**PDPLANPMTD-2023/040966**

**PROPOSAL:** Additions & Alterations (Single Dwelling)

**LOCATION:** 7 Buchanan Street, Bellerive

**PDPLANPMTD-2023/040966 - Planning Permit Discretionary  
- 7 Buchanan Street, Bellerive**

Site Plan

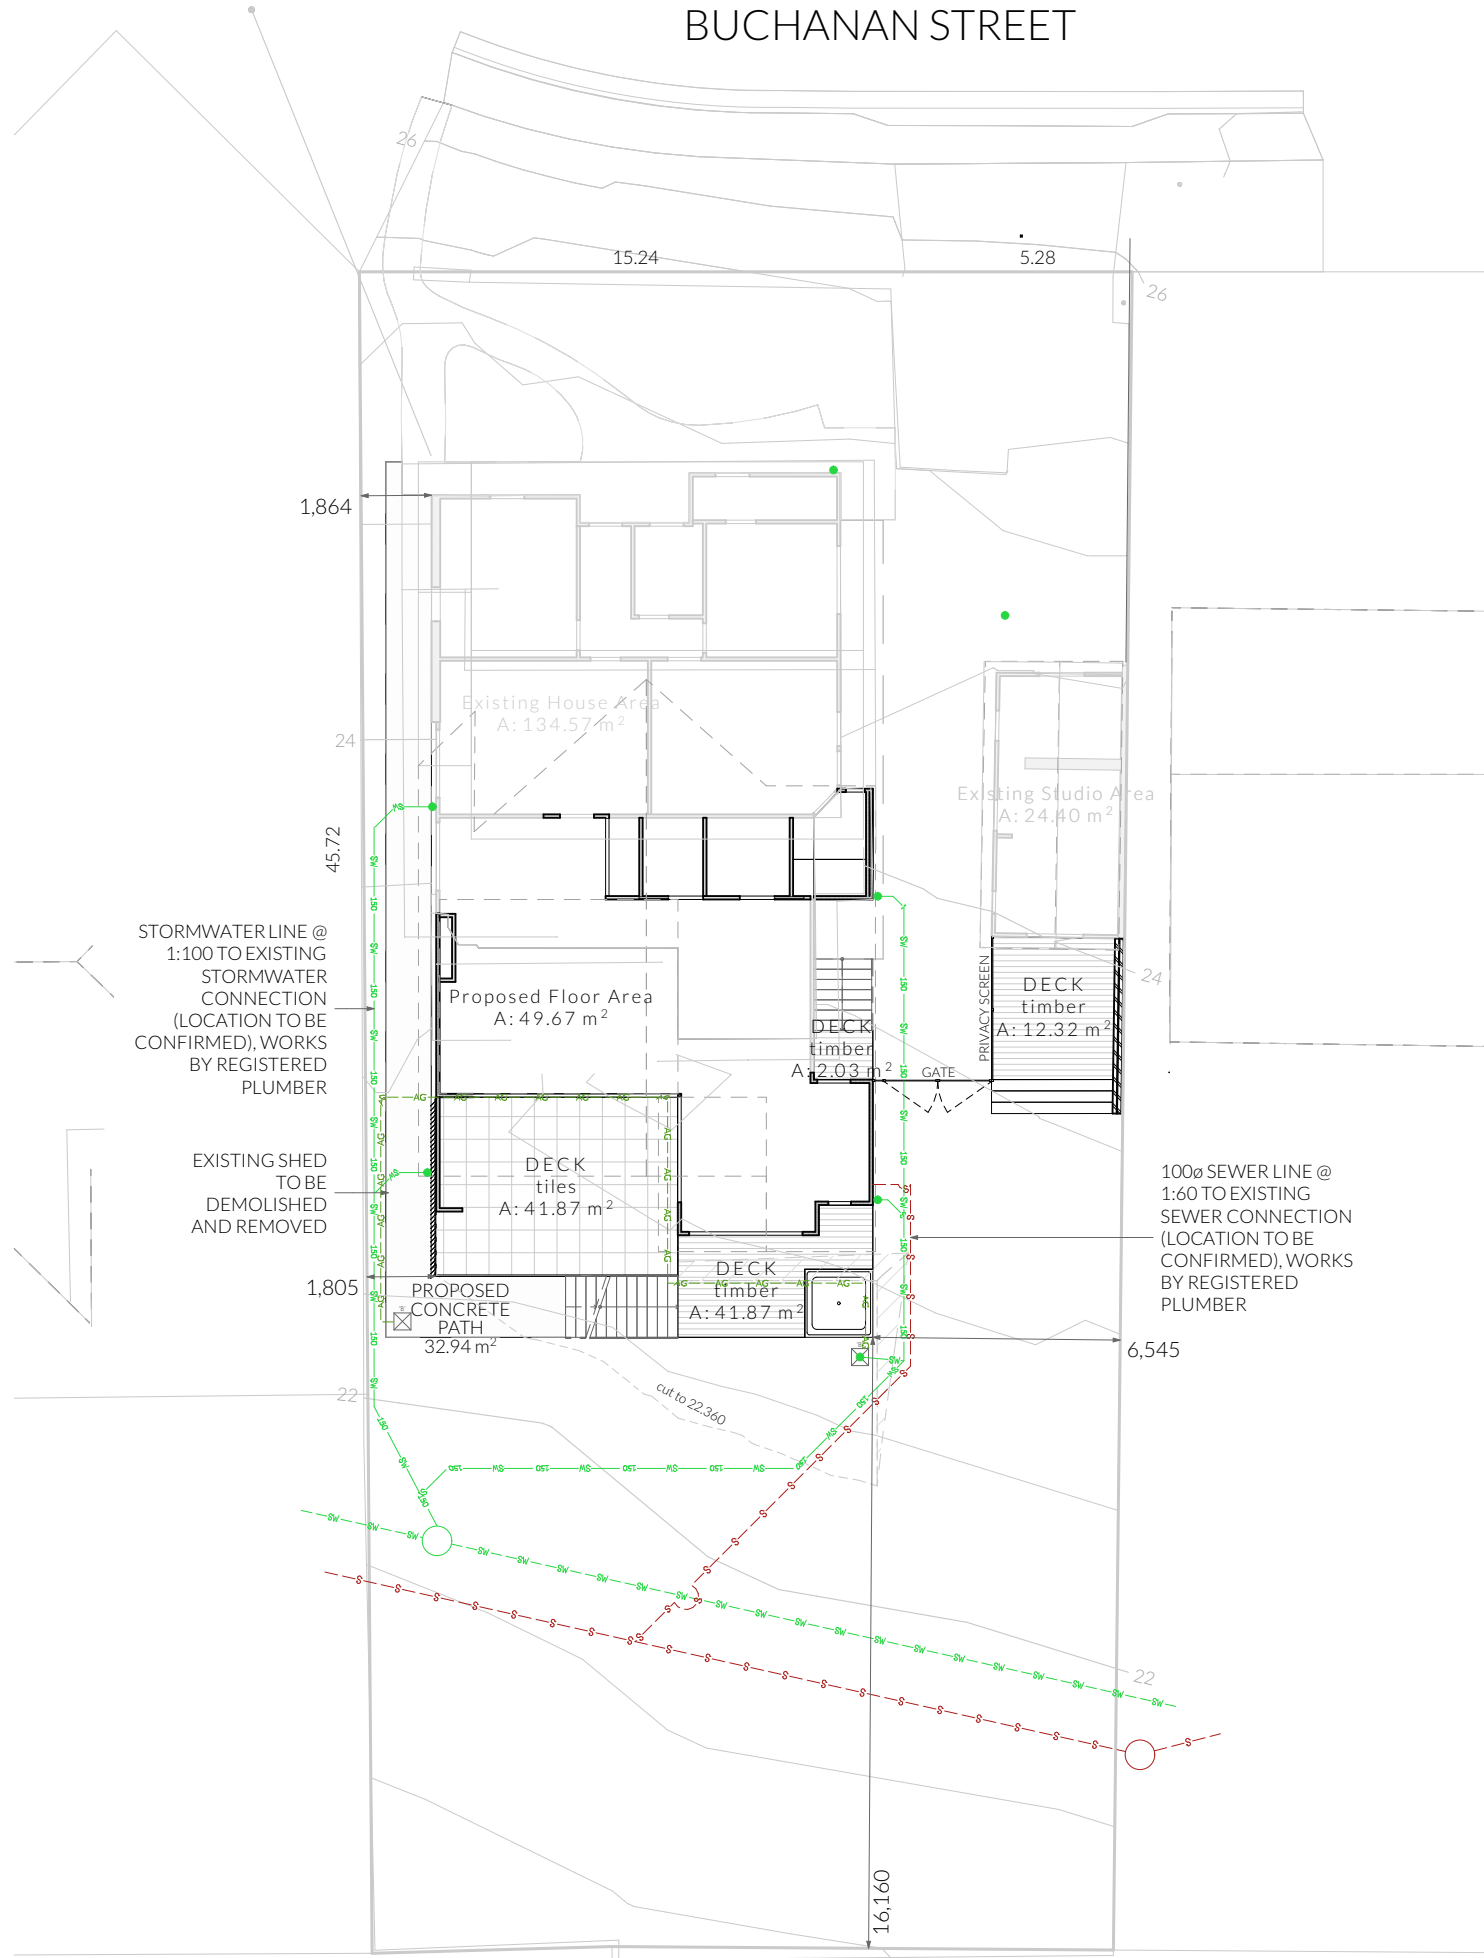
3	<i>Paranville Specific Area Plan – River Face Precinct CLA-S21.7.3 Excavation and retaining walls (A1) Please provide details of the intentions for the area below the deck and any proposed excavation works on site.</i>	The excavation is a minor cut underneath the deck to allow for storage. Max height 600mm

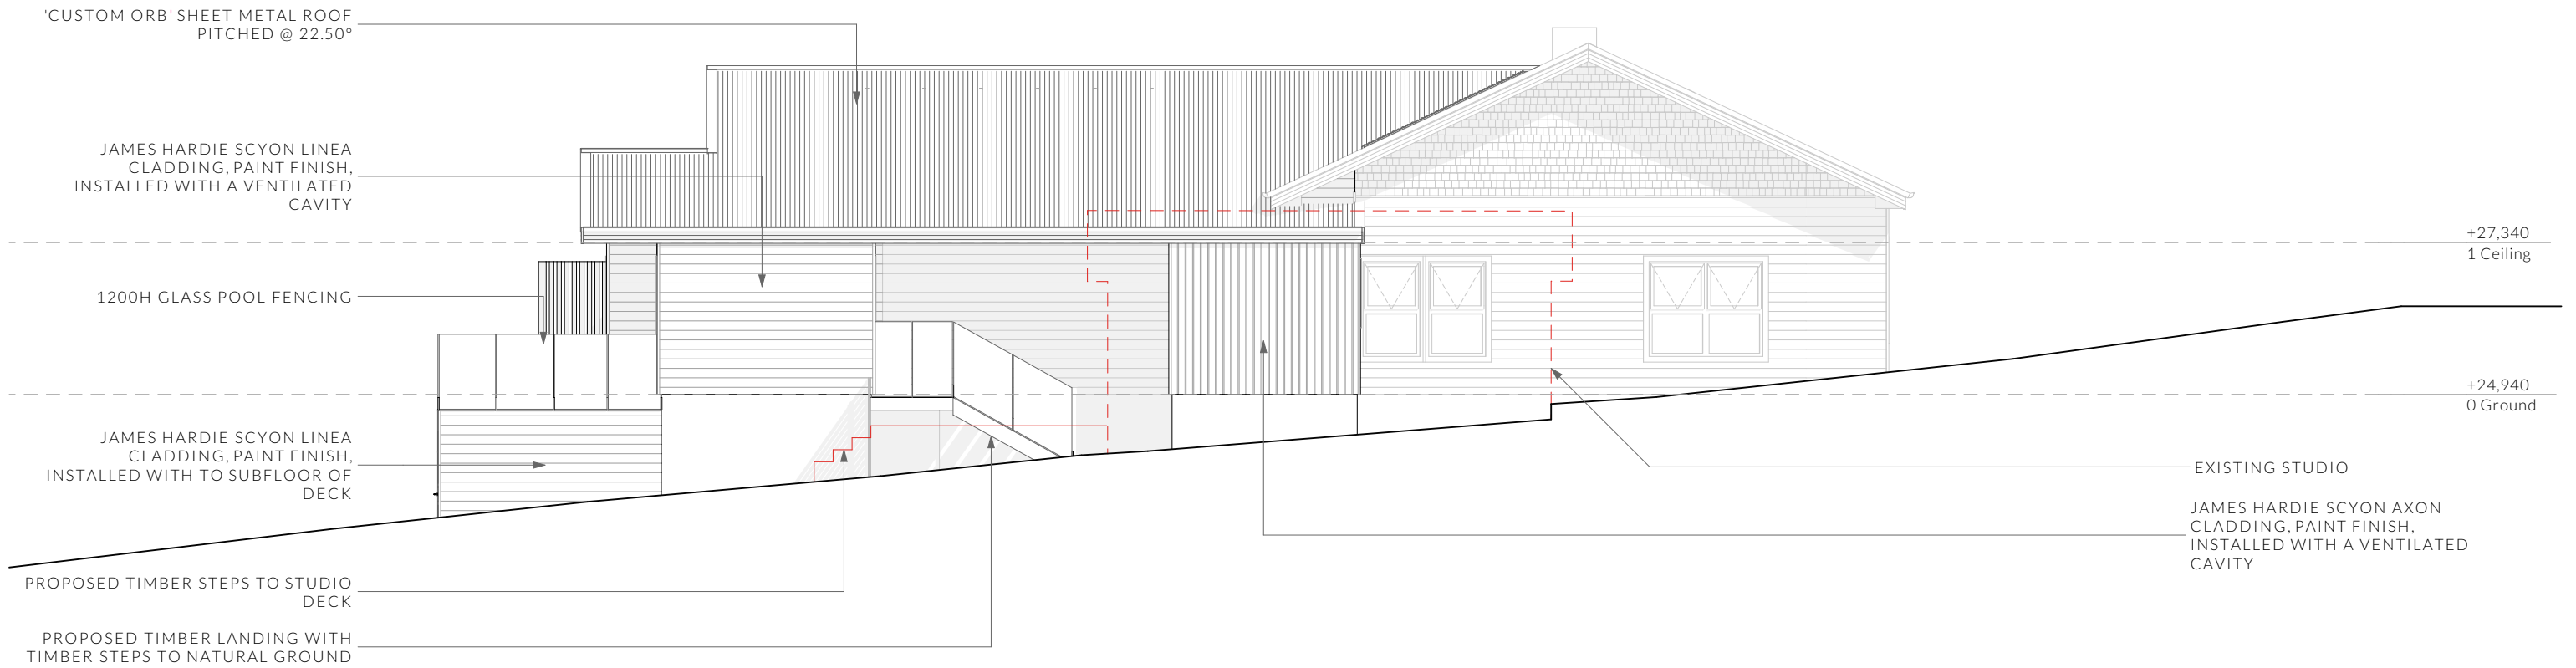
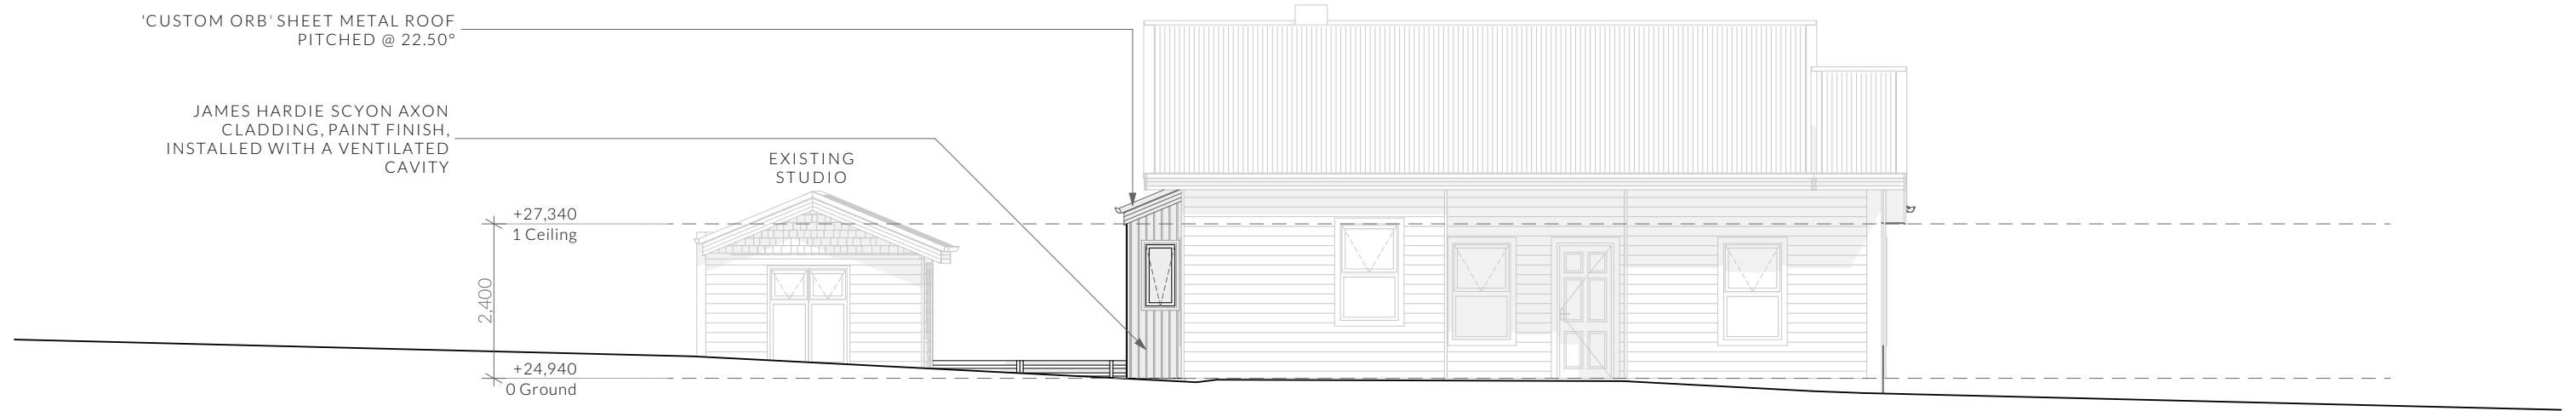
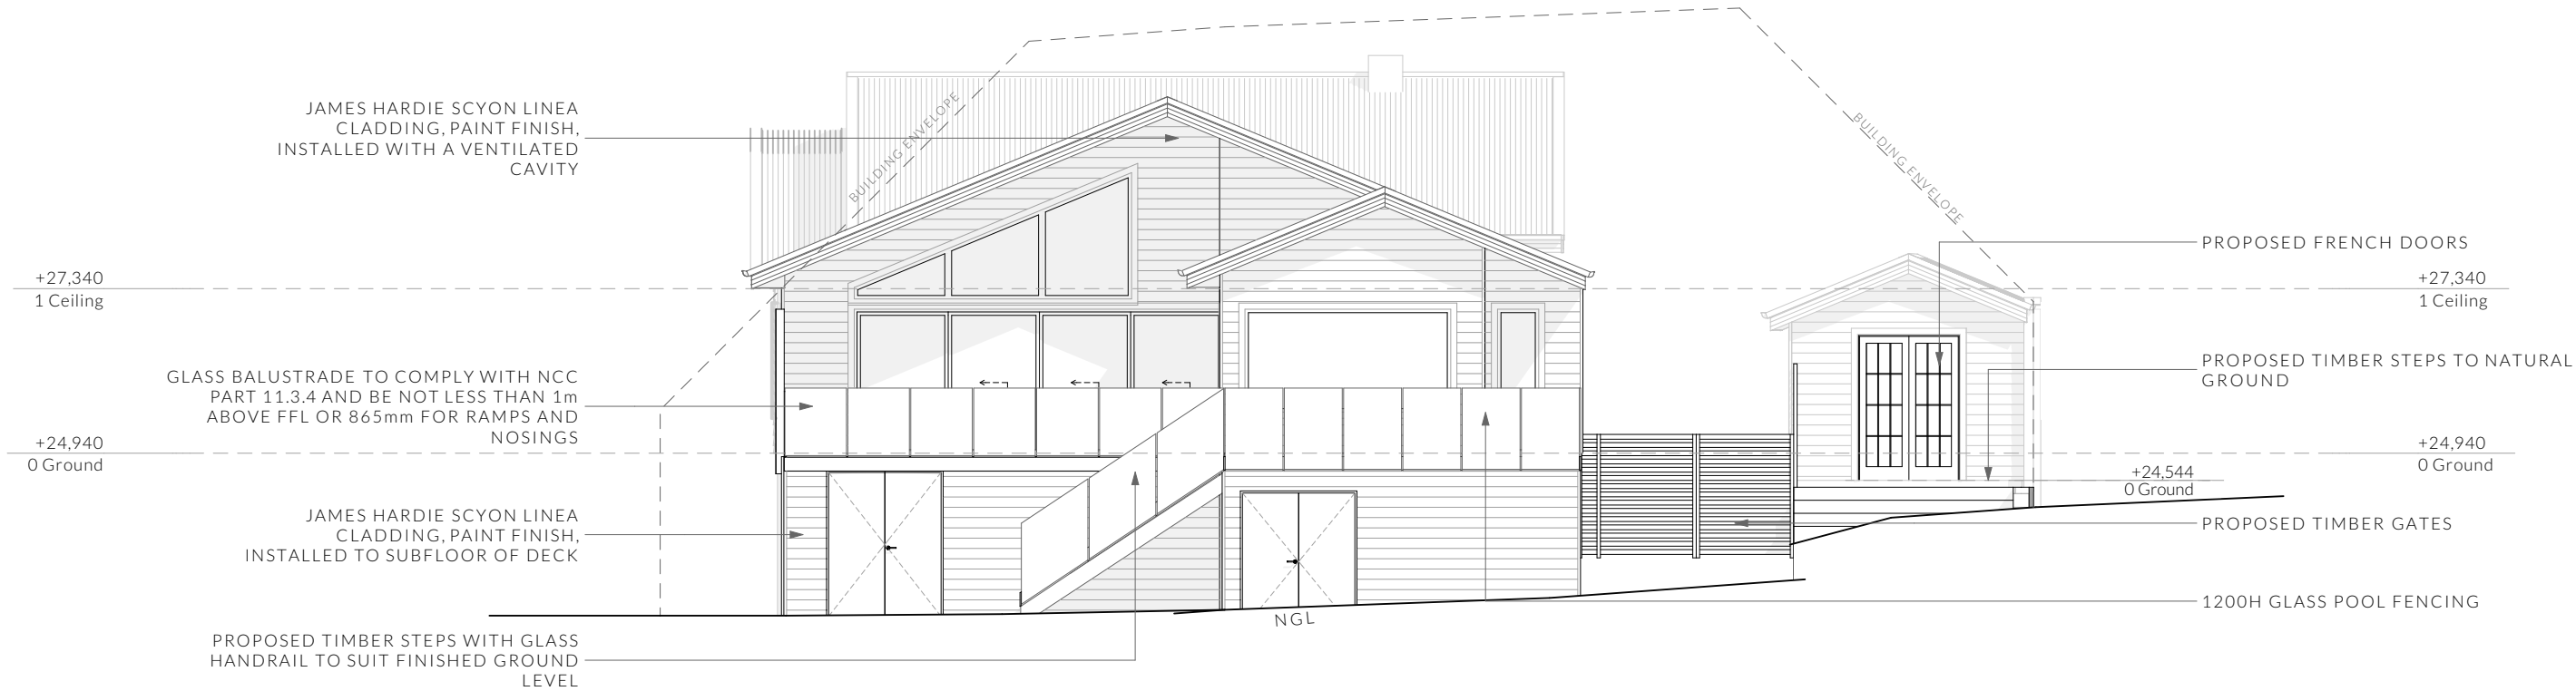
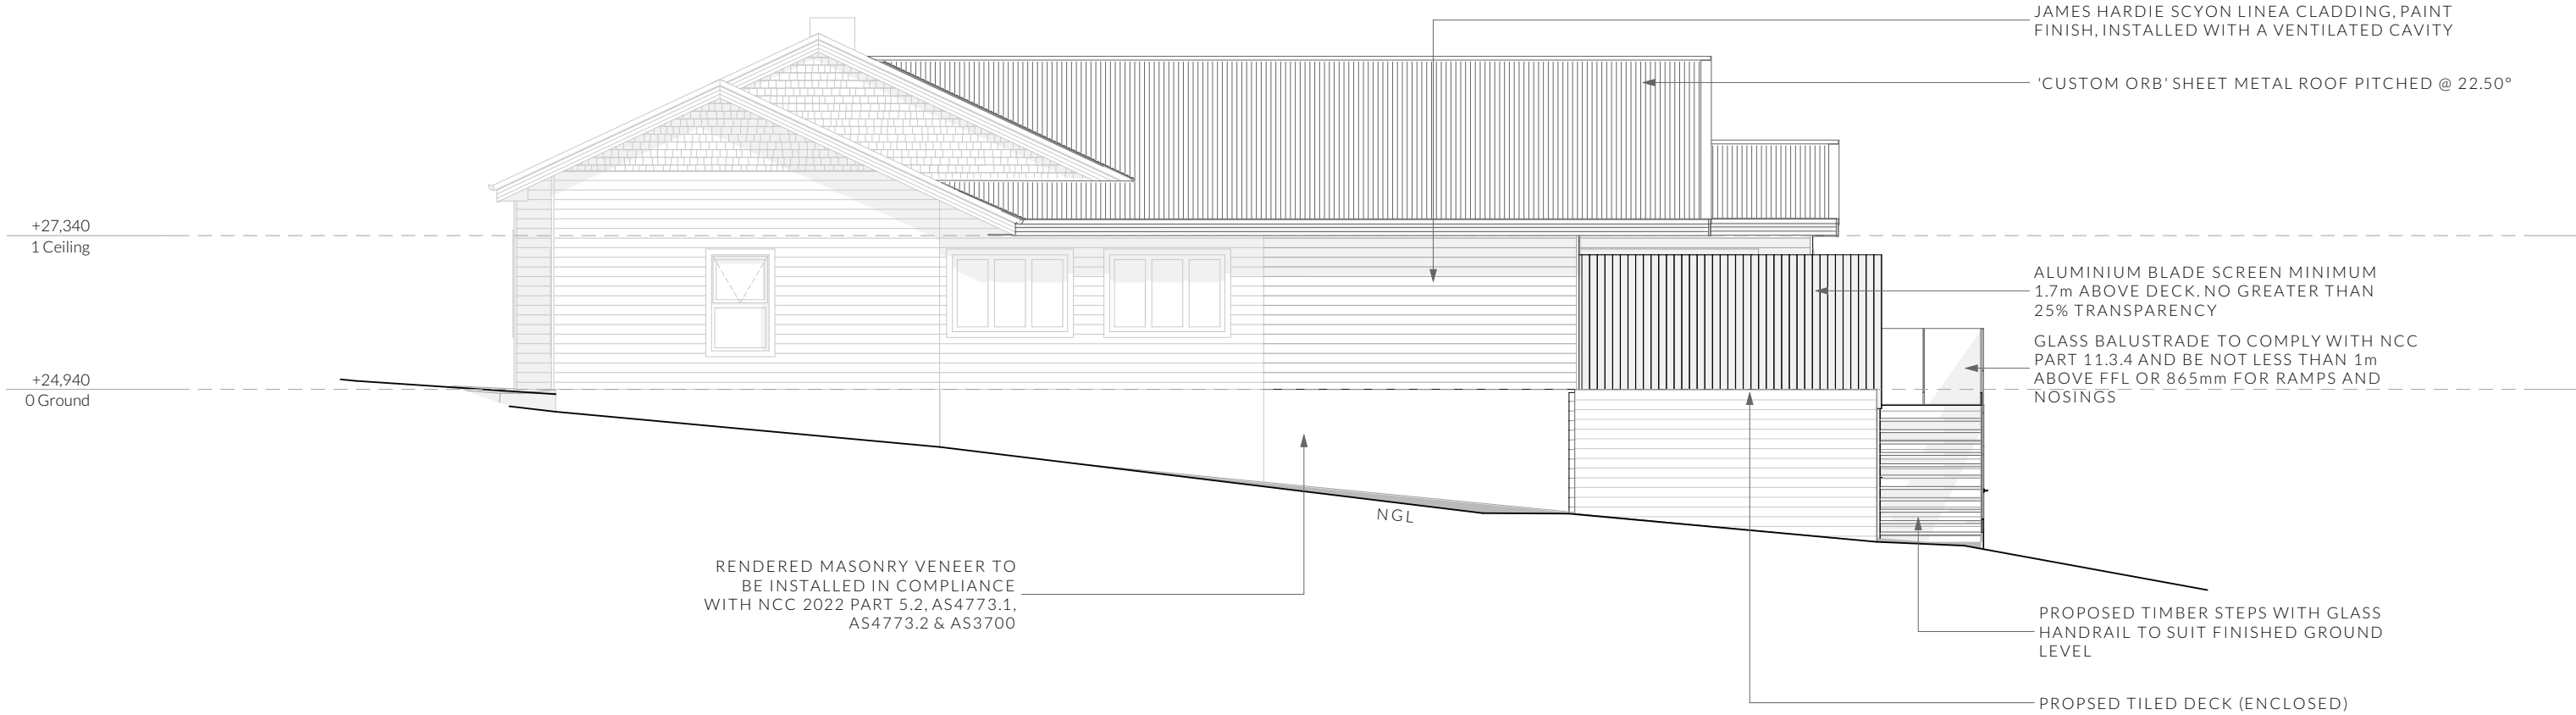
ITEM	COUNCIL REQUEST	DEVELOPMENT RESPONSE
1	<i>8.4.2 Setbacks and building envelopes for all dwellings (A3) As part of the proposed extension protrudes the building envelope prescribed at the above Clause (see image below), your proposal will need to be assessed against the corresponding Performance Criterion, P3. Please provide additional information enabling us to assess your proposal against P3, including shadow diagrams and an evaluation of the visual impacts caused by the apparent scale, bulk or proportions of the dwelling when viewed from an adjoining property.</i>	Shadow diagrams have been provided which show minimal overshadowing increases from the new extension.
2	<i>8.4.6 Privacy for all dwellings (A1) Please amend the drawings to show a privacy screen for the entire length of the proposed deck on the north-western elevation (as highlighted below). Please also add a specification to the drawing set that the proposed privacy screen is to be of no greater than 25% transparency.</i>	The privacy screen has been extended
